To professors R. Vogt and S. Whitcomb  
from V. Braginsky

January 17<sup>th</sup>, 1994

I had no direct contacts with the LIGO team since February 6<sup>th</sup> 1993, and <sup>probably</sup> it will be interesting for you to know my opinion about the results achieved by the team during these 11 months in the area, which briefly may be called "suspension". I have conversation with Fred Raab and Aaron Gillespie, I saw the installation in the basement, which permits to test the quality factors of the pendulum modes, violin modes and internal modes. And I may say absolutely sincerely that I am impressed and satisfied with the obtained numbers for  $Q_{\text{pend}}$ ,  $Q_{\text{viol}}$  and  $Q_{\text{intern}}$ . I may say, that these numbers looks good for "the first approximation" of the suspension system despite the fact, that the numbers were obtained in different version of suspension which were favorable separately for pendulum, violin and internal modes.

FIG 1.

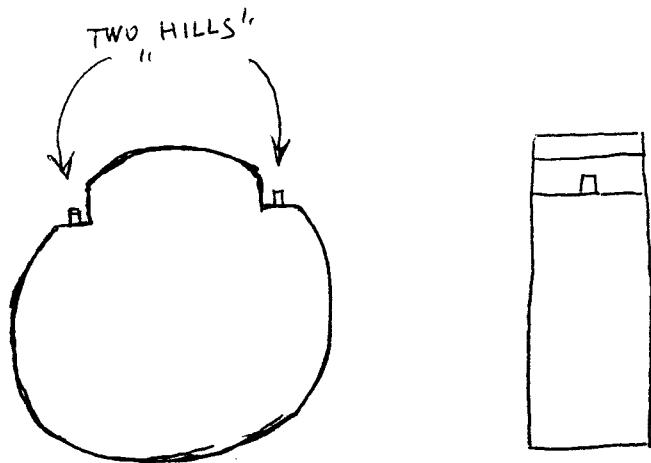
1. To ask the manufacturers to cut out some fraction of the test masses to have two small, cylindrical shape "hills", as it is shown in the FIG 1. I may add that in Moscow our technicians are doing this type of "body shaping" without assistance: they use only a diamond drill.

The "hills" have to be 0.2 - 0.25 cm in diameter and higher than 0.3 cm.

FIG 2

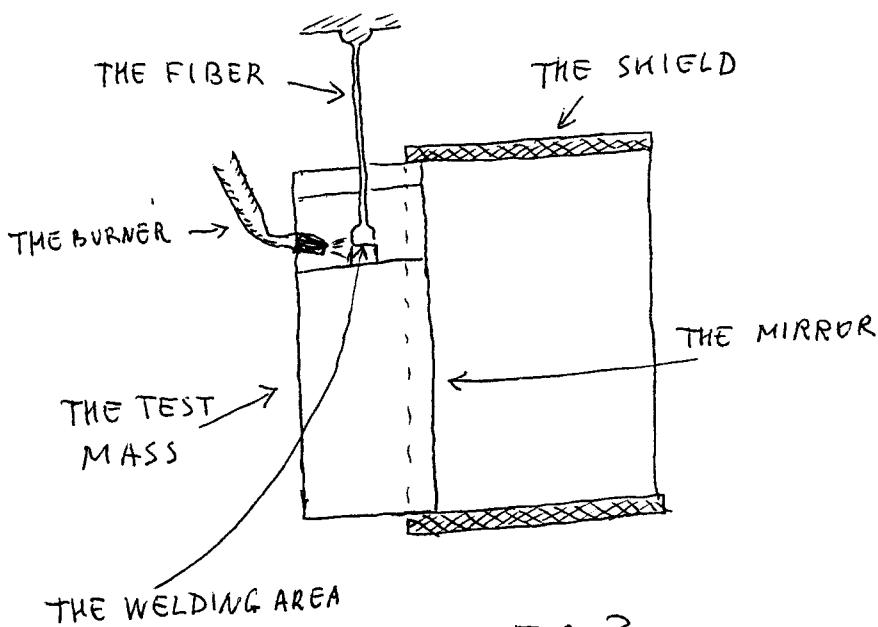
2. To ask the manufacturer to make a deep annealing of the test mass after the cutting (the numbers we got in MSU were obtained without this procedure, but I guess, that deep annealing will help with the quality factor of the internal modes)
3. To polish the part of the surface, which ~~is~~ was damaged by the diamond drill.
4. To cover the surface with the multilayer reflector (coating).
5. To weld to the "hills" the massive part of the prepared in advance fused silica fibers ends. In this last procedure it is necessary to add a shield to protect the mirror from open fire (see FIG 2)

If the shield will be done properly (no slots between its inner surface and the surface of the test mass), then I guess that the mirror will not be damaged by a small ( $1 \div 2$  cm long) open fire.

FIG 3.

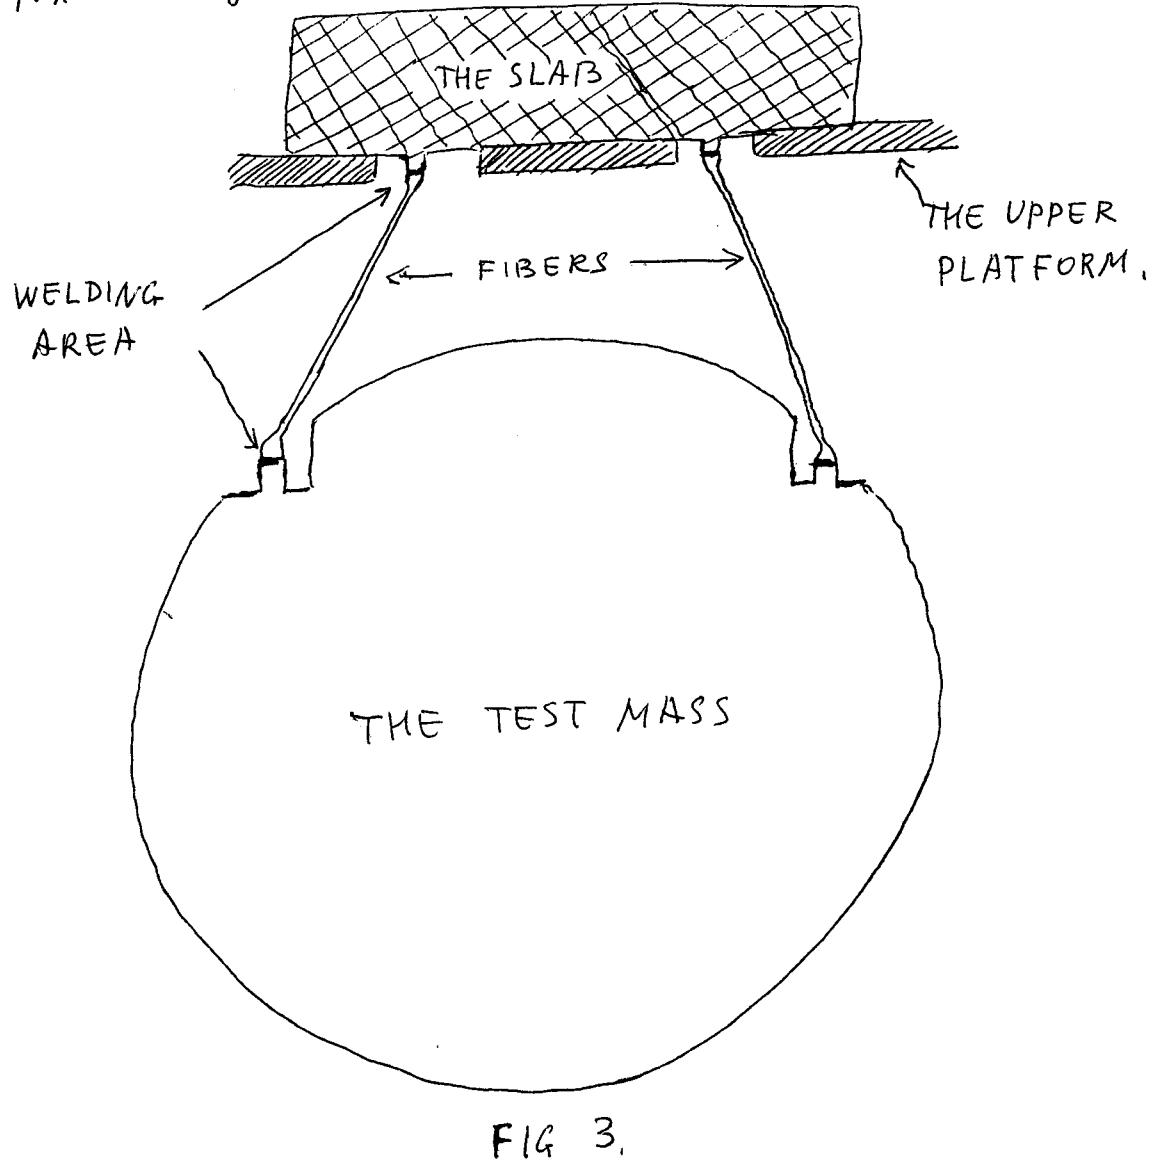
I also strongly recommend to repeat our trick with the massive slab in the upper part of the suspension (also with two mini "hills") to reduce the leakage in the upward direction. The mass of the slab has to be larger than the test mass. Thus the final design of the suspension may look like FIG 3.

FIG. 1.

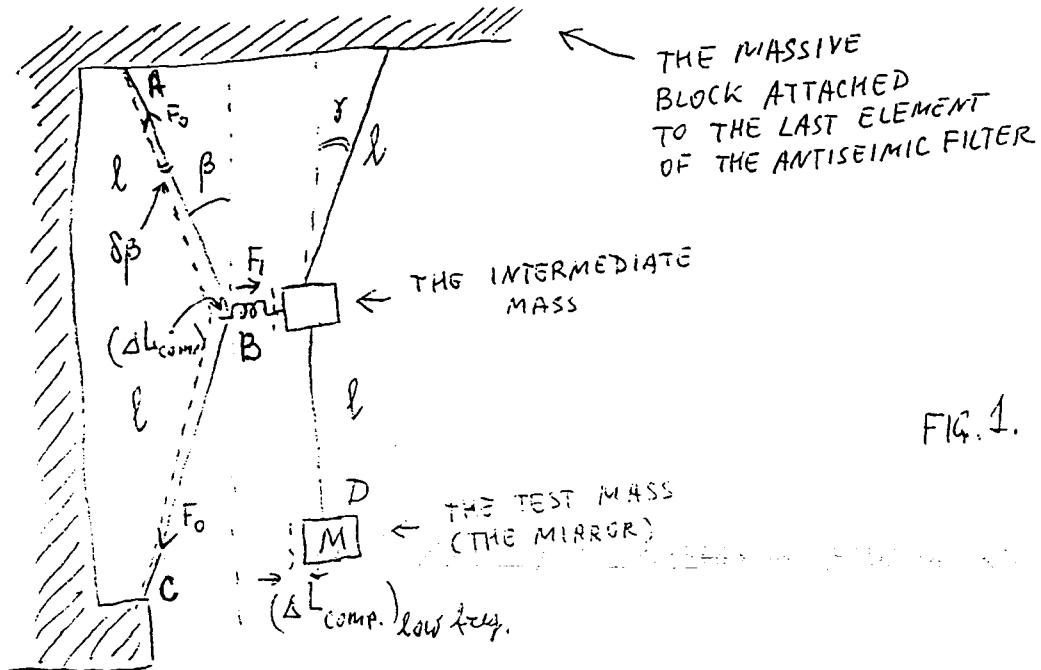
I consider as one of the possible ways to get a force  $(F_{\text{comp}})_{\text{low freq.}} \approx 2.5 \times 10^4$  in the scheme which is presented on the FIG 1

The idea is simple: the wire ABC in its middle is attached to the intermediate mass. By the heating the wire due to its thermal expansion coefficient  $\alpha_{\text{wire}}$  it is not difficult to obtain

For  $l=20 \text{ cm}$ , ~~the~~  $\delta \beta \simeq 5 \times 10^{-3} \text{ rad}$  ~~the~~ the necessary change of the temperature

$$F_1 \simeq 3 \times (\Delta L_{\text{compens}})_{\text{low freq}} \times \frac{Mg}{l} \simeq 1.5 \times 10^5 \text{ dyn} \text{ and } F_0 \simeq \frac{F_1}{2\beta} \simeq \frac{1.5 \times 10^5 \text{ dyn}}{2 \times 5 \cdot 10^{-3}} \simeq 1.5 \cdot 10^6 \text{ dyn}. \quad (6)$$

If the wire has the diameter  $2 \times 10^{-2} \text{ cm}$  and it is made of tungsten then the strain will be  $5 \times 10^{-9} \frac{\text{dyn}}{\text{cm}^2} \simeq 10^{-3}$  (Young modulus of tungsten), which is a tolerable value. This wire with the above parameter will have the heat capacity  $C \simeq 1 \times 10^{-2} \frac{\text{Joules}}{\text{deg}} = 1 \times 10^{-5} \frac{\text{erg}}{\text{deg}}$  (for  $l=20 \text{ cm}$ ) and a relatively long ~~the~~ thermal relaxation time  $T_{\text{therm}}^*$ :

FIG 2

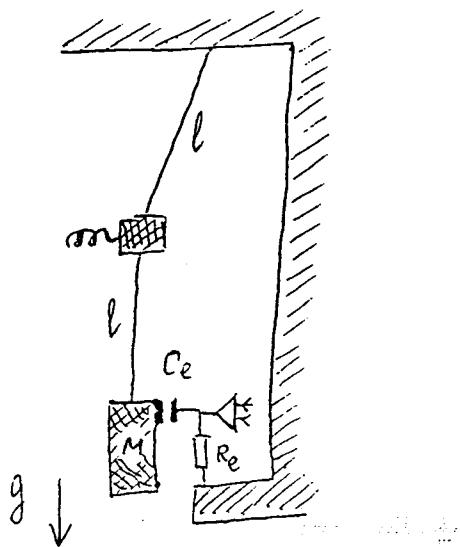
To compensate  $\Delta L_{(c)}$  it is possible to use a direct force  $\Delta F_{\text{high freq.}}^{(c)}$  produced by electrostatic ponderomotive effect in a capacitor (see FIG 2)

If the square are of the capacitor's plate is  $S$  and the distance between the plates is  $d \approx 2 \times 10^{-1} \text{ cm}$  (two times larger than  $\Delta L_{(4)+(6)}$ ) then the condition for the applied potential  $U$  are:

where I assumed that  $S = 25 \text{ cm}^2$  (5% of one side surface of the mirror is "sacrificed" to produce  $\Delta F_{\text{high frequency}}^{(c)}$ ) and  $U = 1.8 \text{ CGSE} \approx 400 \text{ volts}$ .

FIG 1

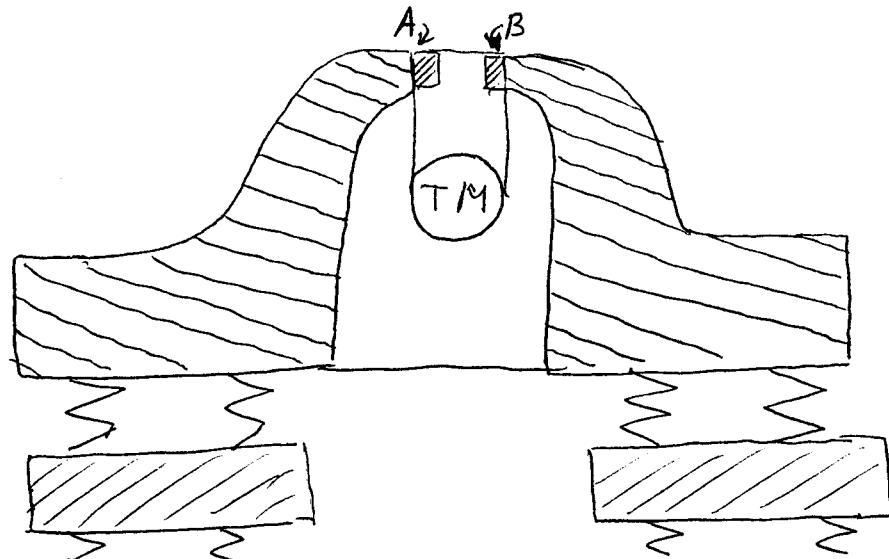
II I recommend to made the copper platform ~~with~~ the shape similar to one presented on the below figure 1

- a) to evade as possible the bolts and nuts in the suspension of the test mass: the strain in them may acts as sources of the excess noise (the discharge of the strain will produce a creep effect).
- b) to make as high as possible all eigen mechanical frequencies of the supporting system and thus to realize better mismatching of the impedances between the wires and the platform itself. I guess that the platform's shape has to resemble the shape of a bell with thick walls and ~~is~~ small windows.  
In addition it would be reasonable to test all important eigen frequencies of the platform.

I also may recommend to weld the wires (in area A and B) to the upper part of the "bell" by means of hard alloys (based on silver with melting point  $> 400\text{ K}$ ).
